FOXCONN		HON HAI Precision Ind. Co., Ltd.	
Title		CCPBG - R&D Division	
Size		Document Number	
Custom		M9A0 MP	
Date:		Wednesday, October 28, 2009	Sheet 5 of 73
		Rev 1.1

FOXCONN		HON HAI Precision Ind. Co., Ltd.	
Title PCH (PCI-E, SMBUS, CLK)		CCPBG - R&D Division	
Size	Document Number	Rev	
Custom	M9A0 MP	1.1	
Date:	Friday, October 23, 2009	Sheet	10 of 73

FOXCONN		HON HAI Precision Ind. Co., Ltd.	
		CCPBG - R&D Division	
Title	VGA (PCI EXPRESS) 1 OF 9		
Size	Document Number	Rev	
Custom	M9A0 MP	1.1	
Date:	Thursday, November 19, 2009	Sheet	21 of 73

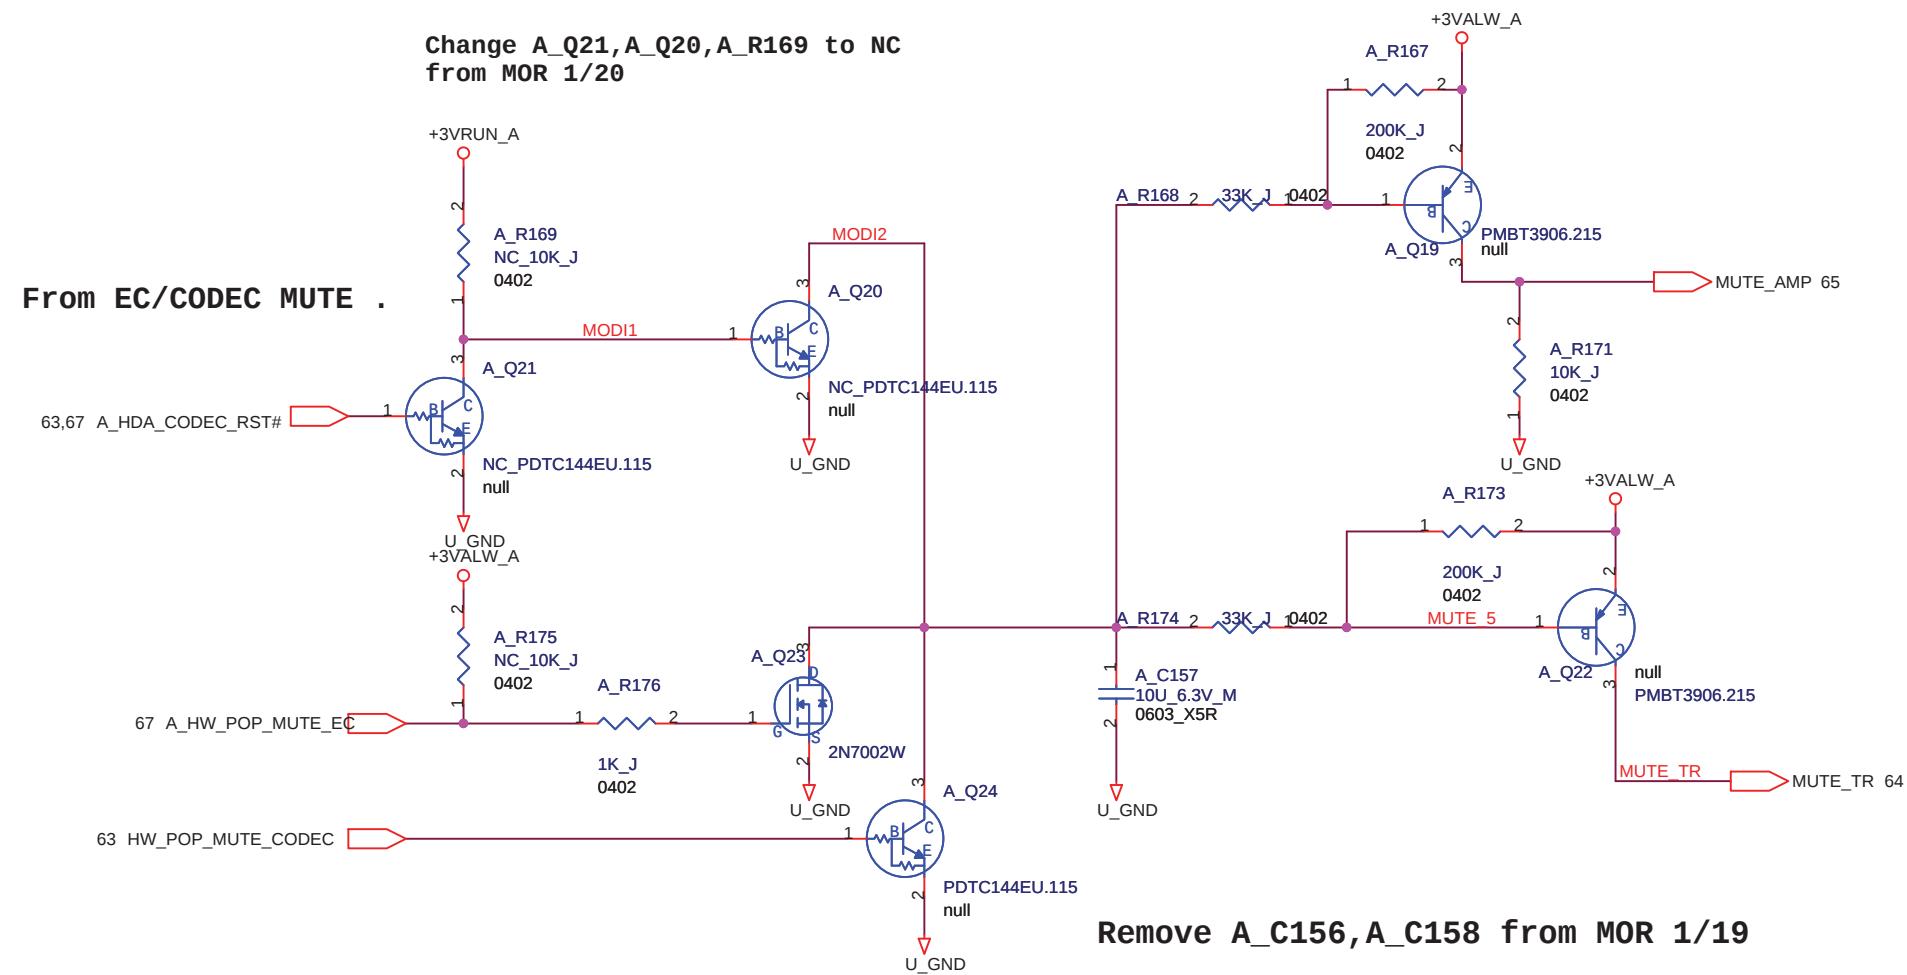
For Mor request,add the speaker cable short protection circuit
